Site Design for a Hotel on Pantops, Charlottesville

A Technical Report submitted to the Department of Civil & Environmental Engineering

The Site Design for a Hotel on Pantops, Charlottesville Final Report

PANTOPS HOTEL
CHARLOTTESVILLE, VA
COVER SHEET

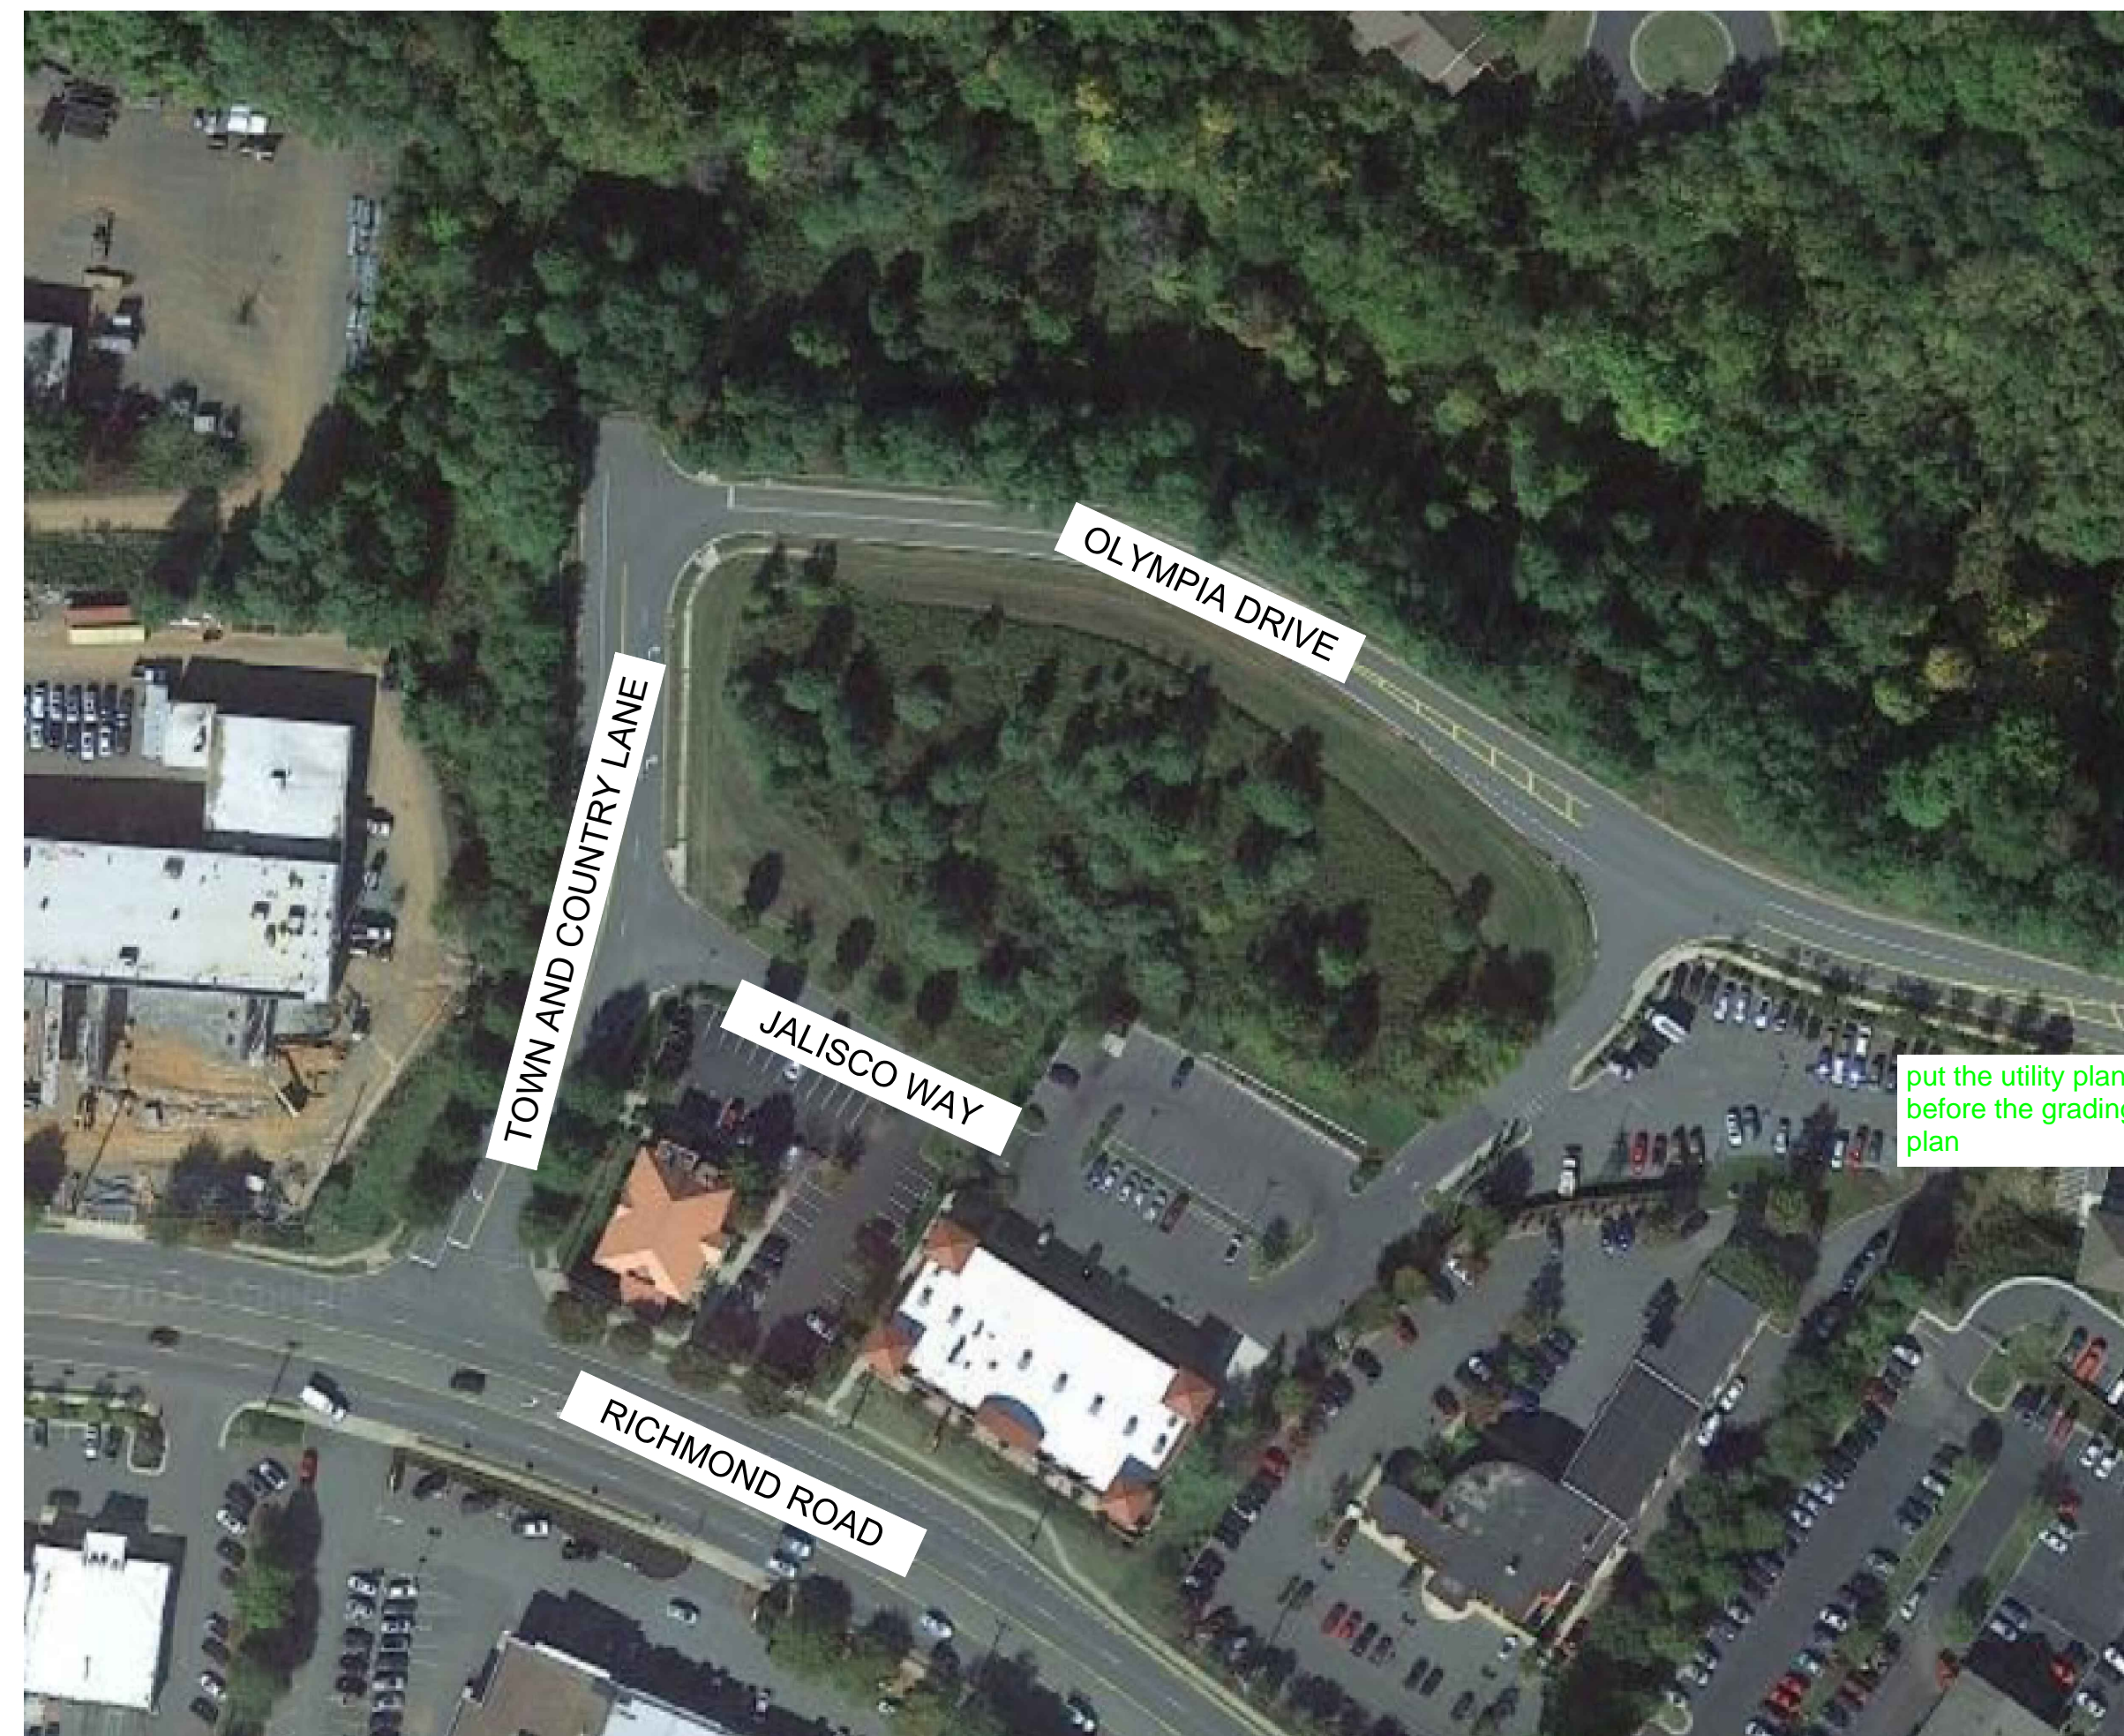
Typically we will add some site and project specific information on the cover like:
Listing the zoning
Identifying the Limits of disturbance is the site in an overlay district?
listing the parking requirements vs. the parking provided

What is listed is typically driven by Site Plan checklists given by the locality which you can find online

put the utility plan before the grading plan

note the scale of the aerial and on the aerial add a label pointing / calling out the site

lets also add a detail sheet (may need a few) for utilities, storm structures, and basic site details such as ada parking, signage, curbs, etc. Water and sanitary sewer details can be found under ACSA design and construction details. These specs are great to reference when designing/ drawing utilities. storm sewer details can be found under VDOT website (although I think they are starting to take away access to this stuff). For site details, you can search "ada parking detail", "cg-6 and cg-2 curb details" etc. and save the image or pdf to a folder on your computer.

this is typically where a seal will go. I know you guys wont have that in the end but typically we will put a descriptor in here like so. You can do this in the titleblock sheet so that you dont have to do it on every main sheet

you can delete out these numbers

lets discuss a plan of attack for these sheets.
